Office Action Summary	Application No. 10/759,061	Applicant(s) BLANCHETTE, MAURICE	
	Examiner Philip Gabler	Art Unit 3637

DETAILED ACTION

3. Claims 1, 3-7, and 9-13 are rejected under 35 U.S.C. 112, second paragraph, as being indefinite for failing to particularly point out and distinctly claim the subject matter which applicant regards as the invention.

Exhibit 1: Mattick '484 Figures 1-3 and 5

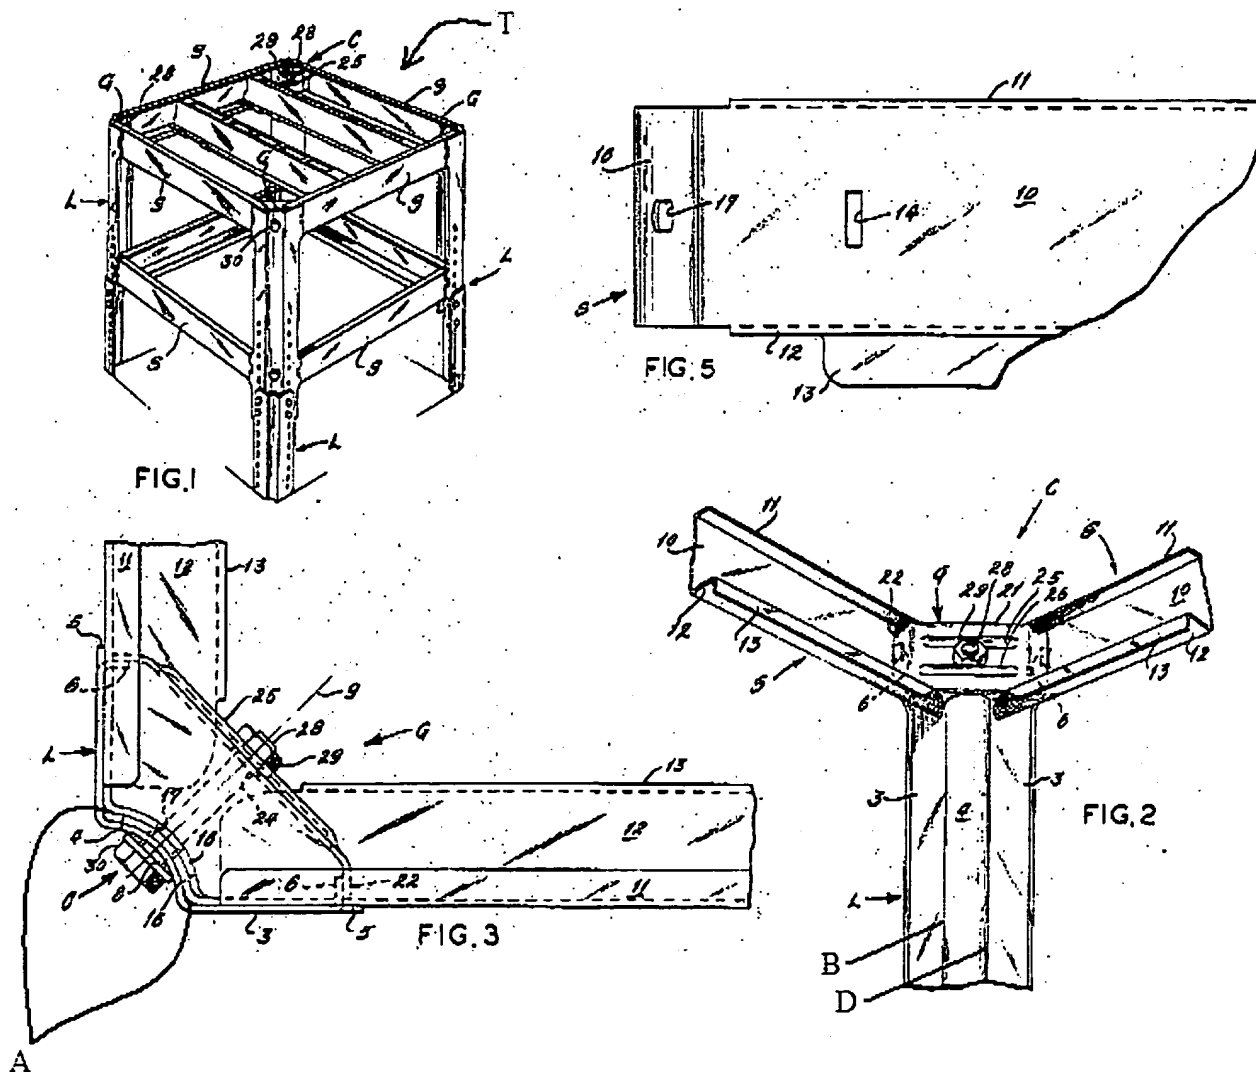
7. Claims 1, 3-7, 9, and 10 are rejected under 35 U.S.C. 103(a) as being unpatentable over Mattick (US Patent Number 3420484) in view of Shelton (US Patent Number 2238348) and Marschak (US Patent Number 3749343). Mattick (Figures 1-3 and 5) discloses a platform assembly (T, Mattick's Figure 1) comprising a weldless frame (components S and L) including at least three side profiles (S) bolted together so as to define a part of a floor, said at least three side profiles each include a folded sheet forming a beam member (S) of C-shaped cross-section, a support column (L) at each corner of said frame, said support column being bolted to said weldless frame, each of said corners being formed solely by one of said support columns and two of said side profiles (at least in as much as Applicant's) extending laterally away therefrom and connected directly thereto (the ends of the side profiles are attached directly to the support columns), said two side profiles having an intermediate web portion (10), and top (11) and bottom (12) flanges folded at about 90 degrees from said intermediate web portion, said bottom flange having a terminal edge portion folded about 90 degrees.

8. Regarding claim 3, Mattick further discloses an open side of said side profiles faces inwardly of said weldless frame.

9. Regarding claim 4, Mattick further discloses side profiles (S) provided with connecting tabs (16) at opposed longitudinal ends thereof, each of said connecting tabs defining a number of holes (14) and (17) for receiving fasteners in order to achieve mechanical connections directly between adjacent profiles and associated one of said support columns at each of said corners (Figure 3 clearly shows a direct connection between the side profiles and an associated column).

10. Regarding claim 5, Mattick further discloses connecting tabs that are folded at 90 degrees (indicated by A in Exhibit 1).

11. Regarding claim 6, Mattick further discloses support columns (L) with two open sides (opposite of sides 3).

12. Regarding claim 7, Mattick further discloses that the open sides face inwardly of said weldless frame (see Figure 2), and wherein each of the cold-formed support columns has a first upstanding portion (3) extending along a first side of the frame, a second upstanding portion (also labeled 3) extending along a second side of the frame, said first and second upstanding portions being provide with respective inwardly bent flanges (6) defining said two open sides therebetween.

13. Regarding claim 9, Mattick further discloses a corner brace (G) at each corner of said frame, each brace being bolted to adjacent profiles extending from the corner.

Shelton '348 Figures 1 and 7

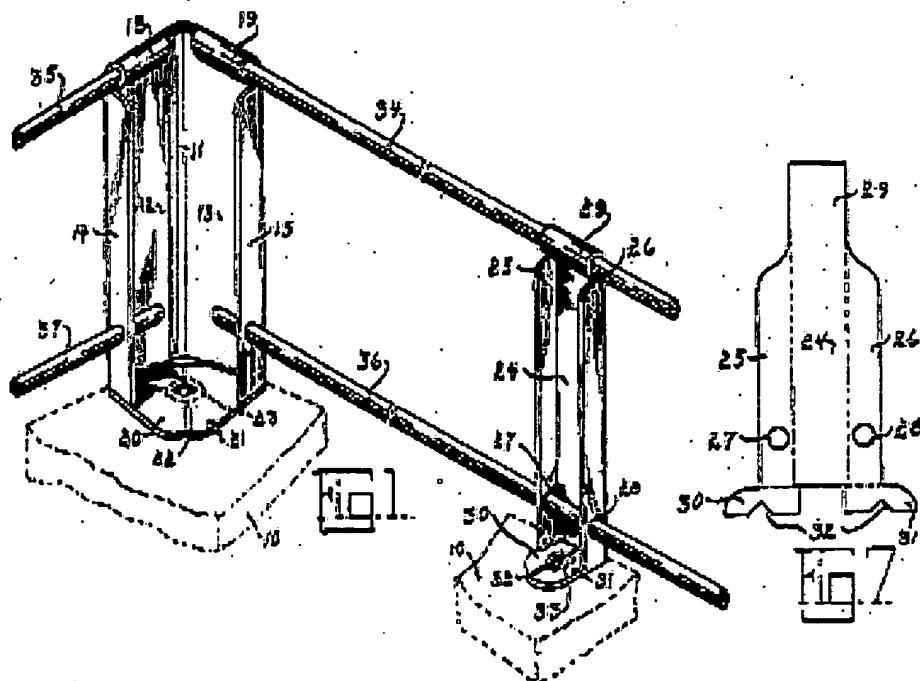
Shelton discloses (Figures 1 and 7) a guard rail projecting upwardly from a portion of a surface (10). Further, the use of steel sheet is well known in the art. Accordingly, it would have been obvious to one of ordinary skill in the art at the time the invention was made to modify Mattick's platform to include a guard rail assembly as taught by Shelton because this would keep objects from falling from the platform (see Shelton column 1 lines 50-51), as well as using steel in the construction of the assembly because of its low cost and high strength. Mattick's table, modified as described above, would be

16. Regarding claim 12, Shelton further discloses a solid tubular rail (36) mounted in his receiving cavity. Note that this claim recites a product by process limitation ("welded"). The product itself does not depend on the process of making it and this limitation would not be expected to impart distinctive structural characteristics to the device.

17. Regarding claim 13, Shelton further discloses a depression (29) defined at the top end of the guard rail post extending across said folds so as to define a seat for receiving a hand rail.

Marschak '343 Figure 3

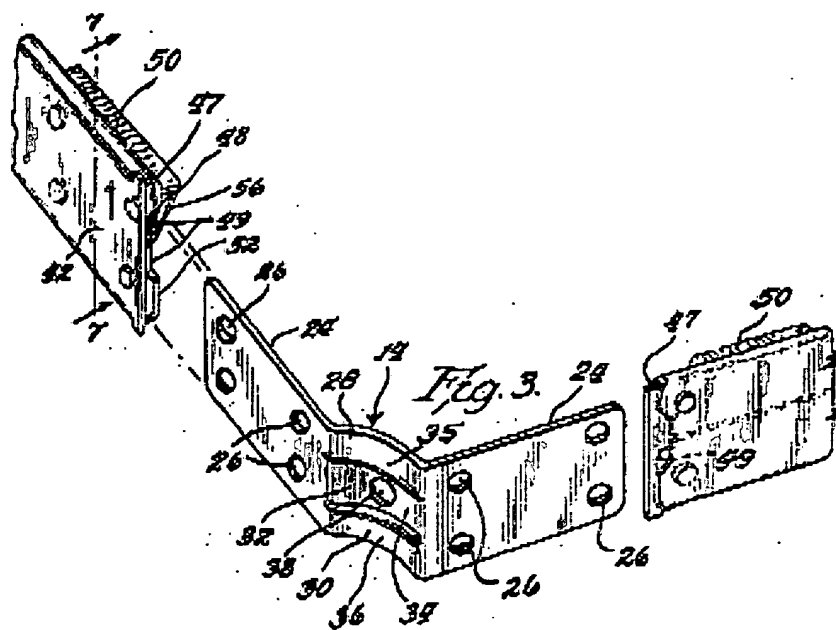
Mattick does not disclose top and bottom terminal edge portions folded inwardly, a guard rail or a specific material for construction, but does disclose the use of metal. Note that the claim recites a product by process limitation ("cold-formed"). The product itself does not depend on the process of making it and this limitation would not be expected to impart distinctive structural characteristics to the device. The use of various flange arrangements for side members is well known in the art as shown by Marschak, who (Figure 3) discloses a shelf/table having a side profile with an intermediate web portion and top and bottom flanges folded at about 90 degrees from said intermediate web portion, said top and bottom flanges having respective terminal edge portions folded inwardly towards one another at about 90 degrees to said top and bottom flanges. Accordingly, it would have been obvious to one of ordinary skill in the art at the time the invention was made to include top and bottom terminal edge portions folded inwardly on Mattick's side profiles, as taught by Marschak, as determined by the needs or desires of a user or to provide a stronger, more substantial side profile design.

Diamond '897 Figures 2 and 4

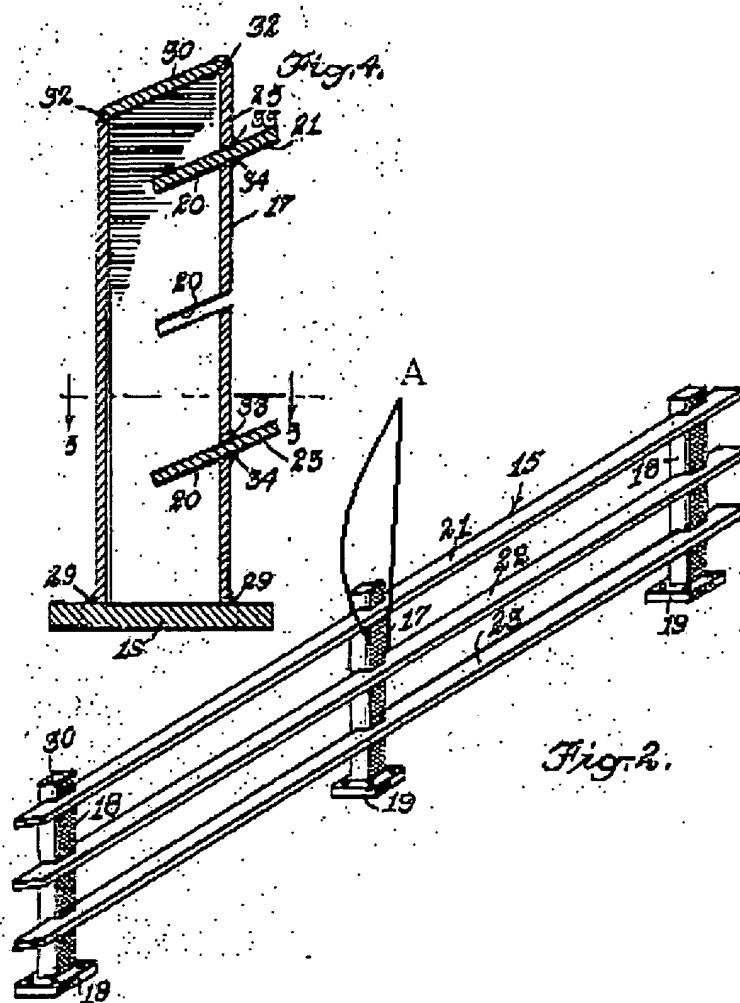
15. Claims 11-13 are rejected under 35 U.S.C. 103(a) as being unpatentable over Mattick in view of Shelton and Marschak and further in view of Diamond (US Patent Number 2733897). Mattick, when modified by Shelton and Marschak as described above, discloses a platform as recited in claim 10 but does not disclose a hole extending through fold lines defining a receiving cavity. Diamond (Figures 2 and 4) discloses a guard rail post having two parallel longitudinal folds (viewed as A in Exhibit 2) and wherein an oblong hole (20) extends transversely through said folds to define a rail receiving cavity on a back side of the post. Accordingly, it would have been obvious to one of ordinary skill in the art at the time the invention was made to modify Mattick's platform, previously modified by Shelton and Marschak, to include an oblong hole through the post (by simply connecting Shelton's holes 27 and 28) to receive a rail as taught by Diamond because this arrangement would provide a simpler method of mounting rails to the guard rail post.
